Product / Process Change Notification (PCN)

PCN #: PCN_IndTFC_20201201

Affected Series: WE-TFC, WE-TFCH; 744861XXX, 744862XXX

PCN Date: November 04, 2020

Marking:

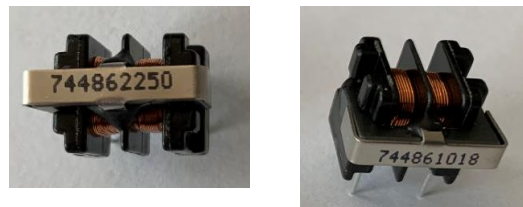
The previous marking will be changed to only the full part number.

Packaging:

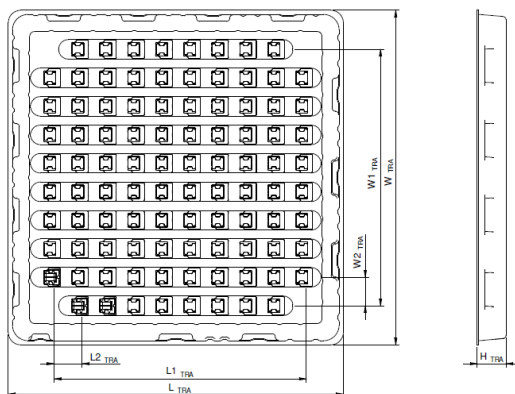
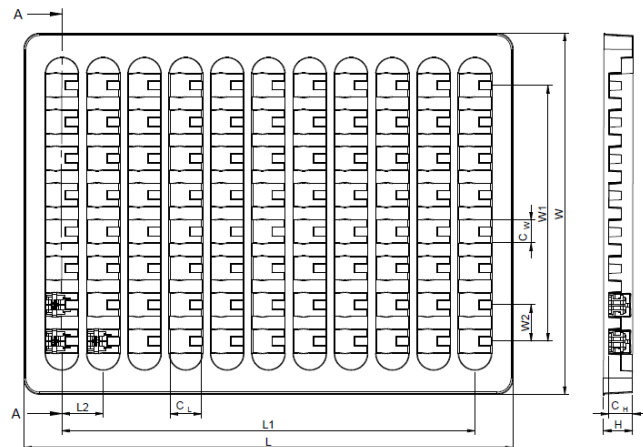
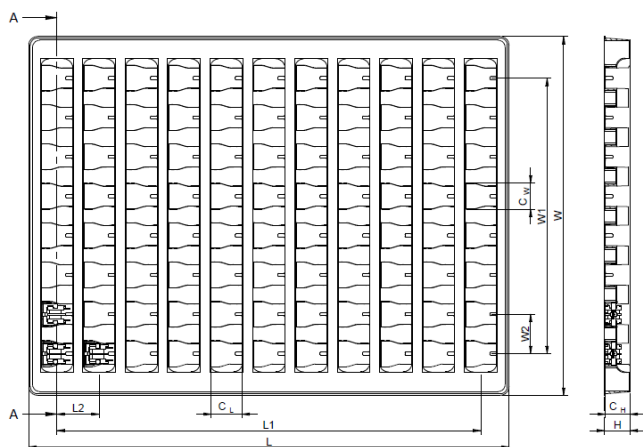
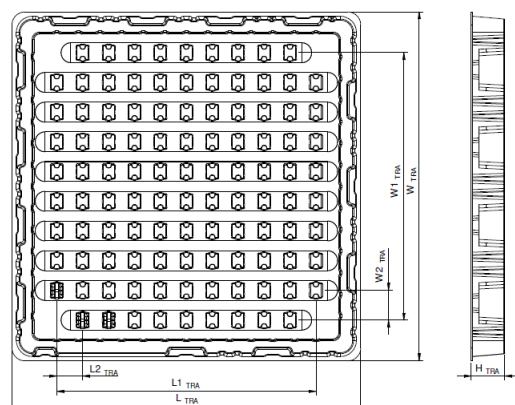
Size UU9.8H		Size UU9.8V	
	Tray	Carton	Tray	Carton
Packaging unit before change	96	672	106	636
Packaging unit after change	88	1584	88	1584

2. Change of the schematic numerationBefore ChangeAfter Change

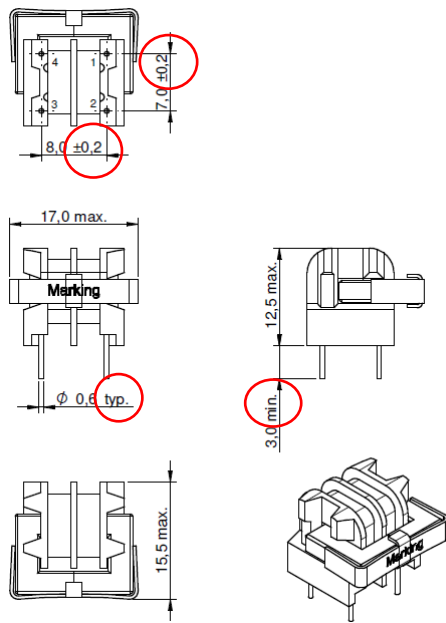
The layout will not be affected.

4. Change of the Test Setup from 2 Port to 4 Port

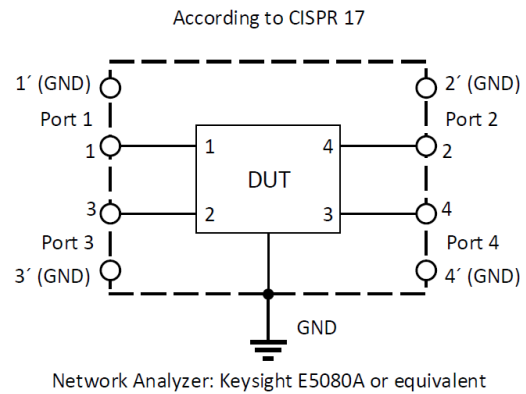
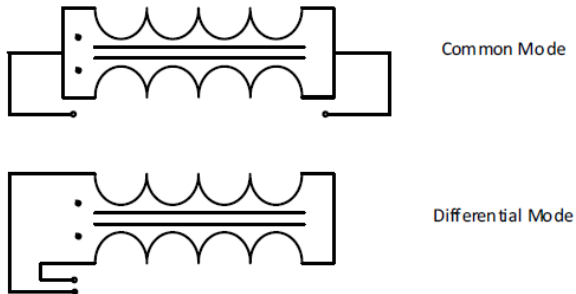
5. Update the Insertion Loss Graph, due to the new measurement setup
